Docket Number:	07-AFC-06C
Project Title:	Carlsbad Energy Center - Compliance
TN #:	203511
Document Title:	Project Owner's Response to Power of Vision's December 27, 2014 Request Regarding Fire Access Roads
Description:	N/A
Filer:	Dee Hutchinson
Organization:	Locke Lord LLP
Submitter Role:	Applicant Representative
Submission Date:	1/9/2015 3:37:02 PM
Docketed Date:	1/9/2015

Re: **Carlsbad Energy Center Project, 07-AFC-06C**
Project Owner's Response to Power of Vision's
December 27, 2014 Request Regarding Fire Access Roads

**RE: CARLSBAD ENERGY CENTER PROJECT,
DOCKET NO. 07-AFC-06C, Fire Access Roads**

FIGURE 2.0-R2
Site Plan
Carlsbad Energy Center Project
Carlsbad, California (07-AFC-06C)
Petition to Amend

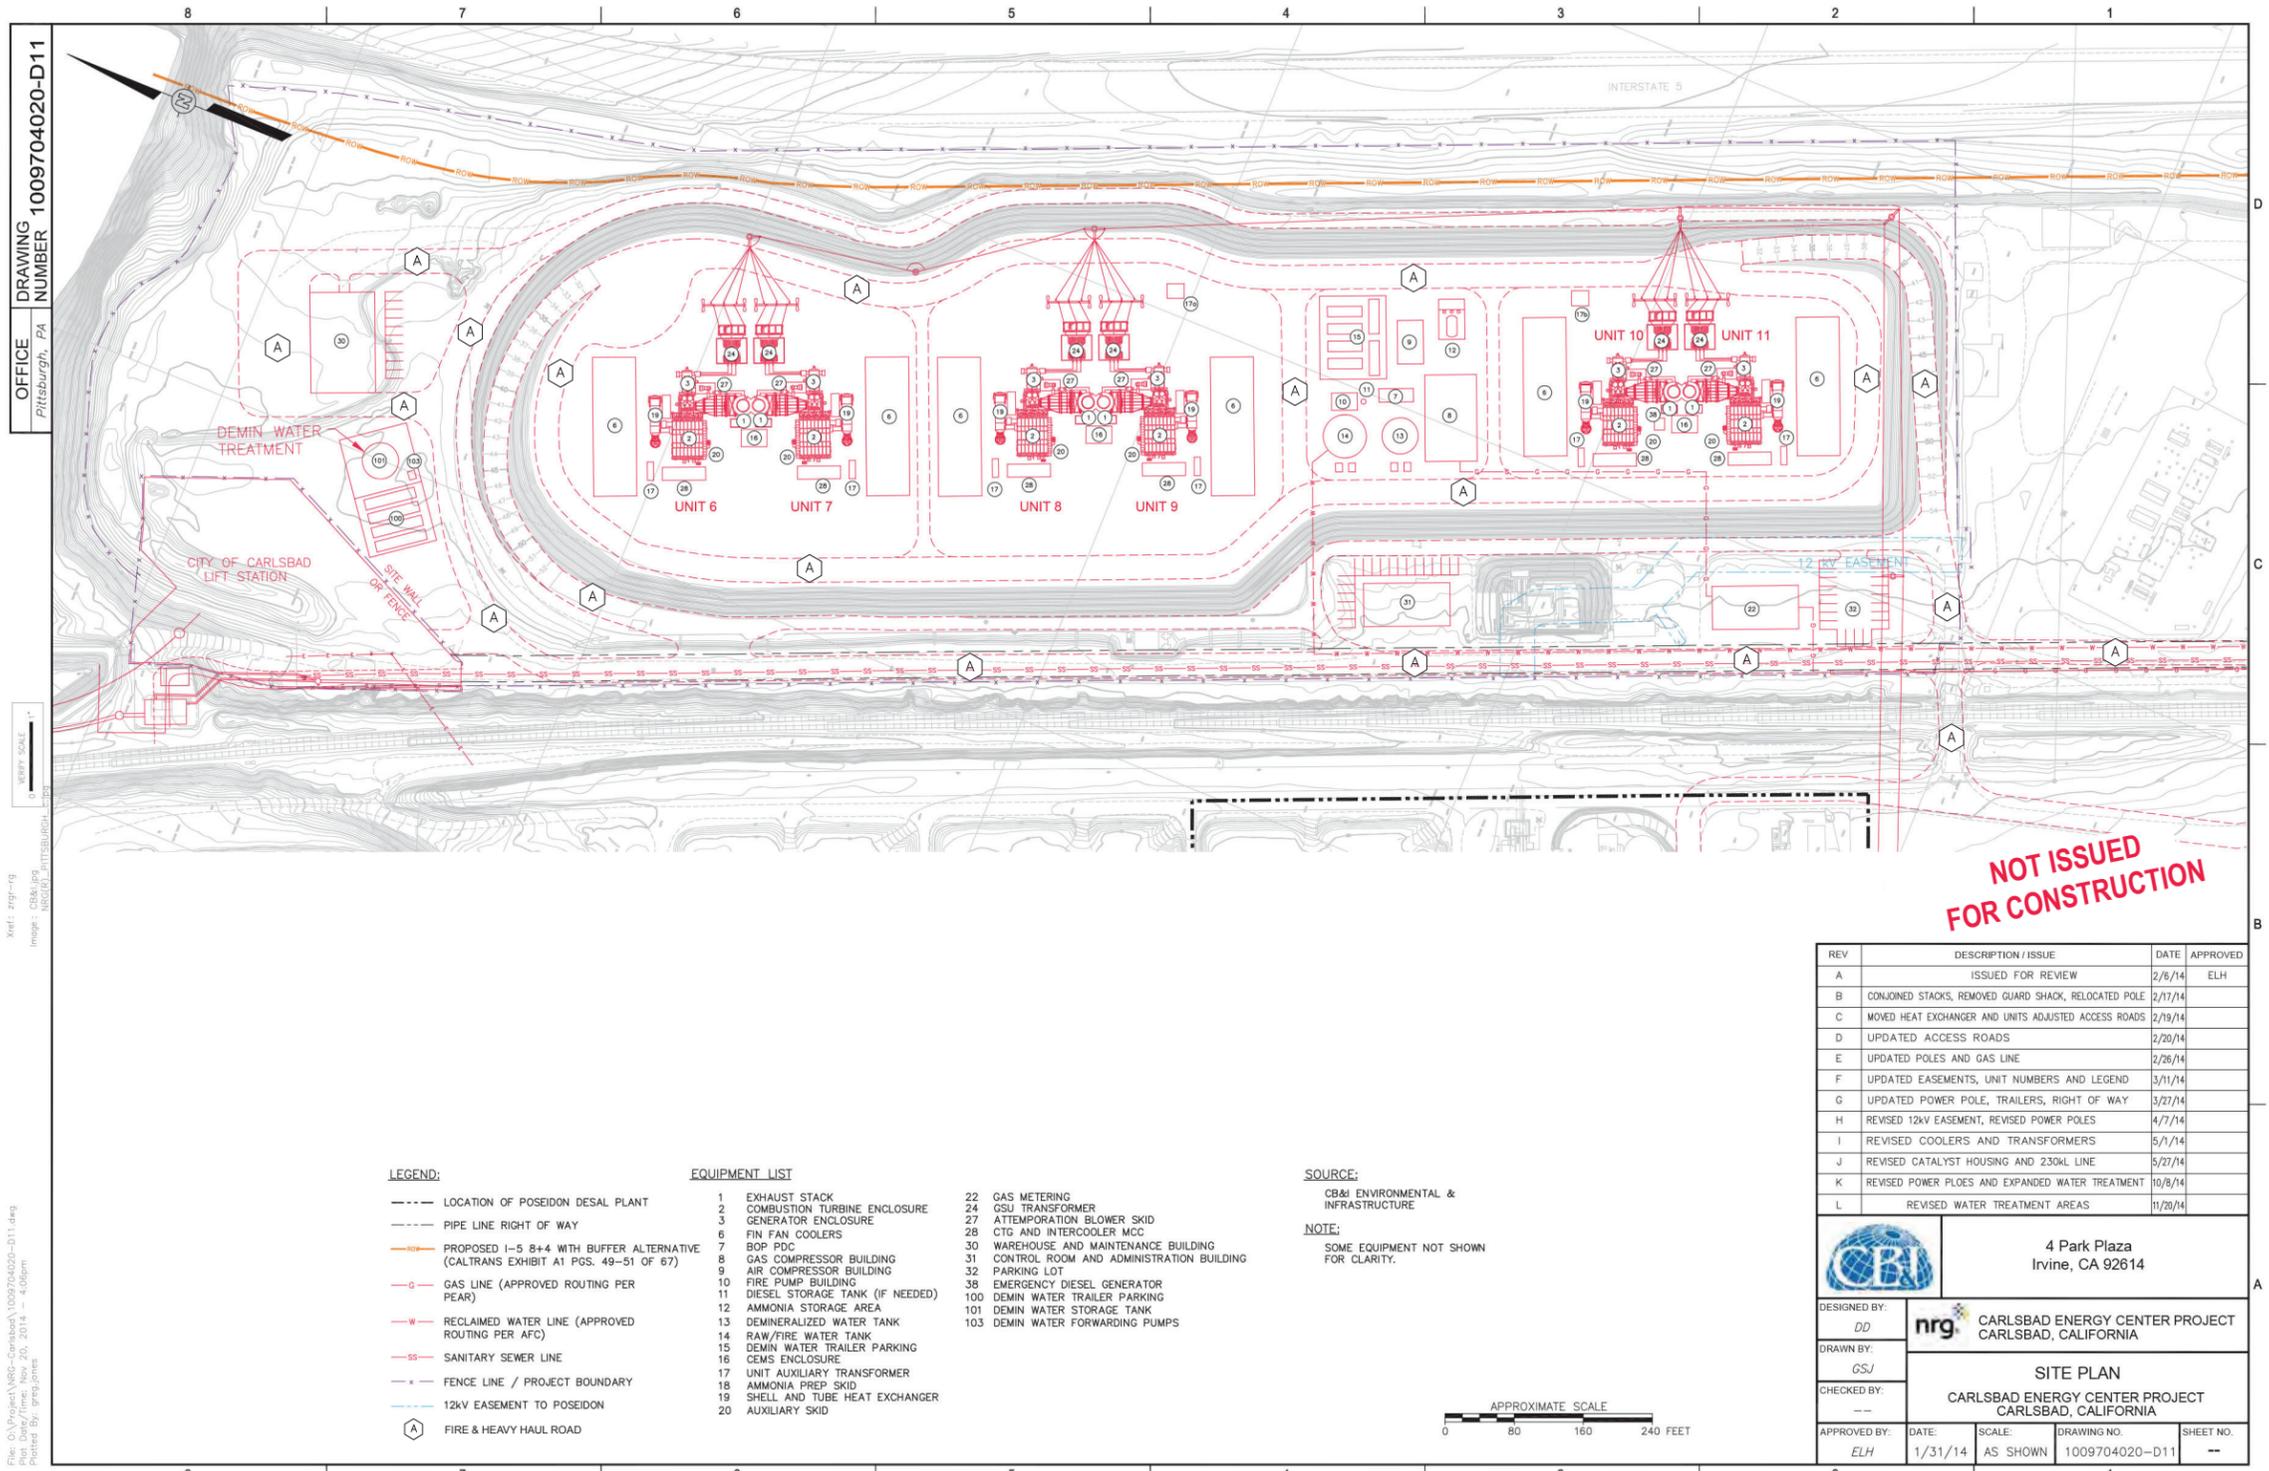
As part of that response, Project Owner has revised two figures that were previously submitted as part of CEC Data Response Set #4, Data Response DR-86-90. Enclosed herein, please find Figure 2.0-R2 and Figure 2.1-R2, revisions to figures 2.0-R1 and 2.1-R1 respectively, which clearly indicate fire lanes (construction and operations) and construction access.

Carlsbad Energy Center LLC ("Project Owner") submits the attached figures in response to your letter received on December 27, 2014, regarding Fire Access Roads. Thank you for your inquiry. The attached figures were previously submitted as part of CEC Data Response Set #4, Data Response DR-86-90, but they have been revised to denote fire lanes (construction and operations) and construction access. Please refer to enclosed Figures 2.0-R2 and Figure 2.1-R2.
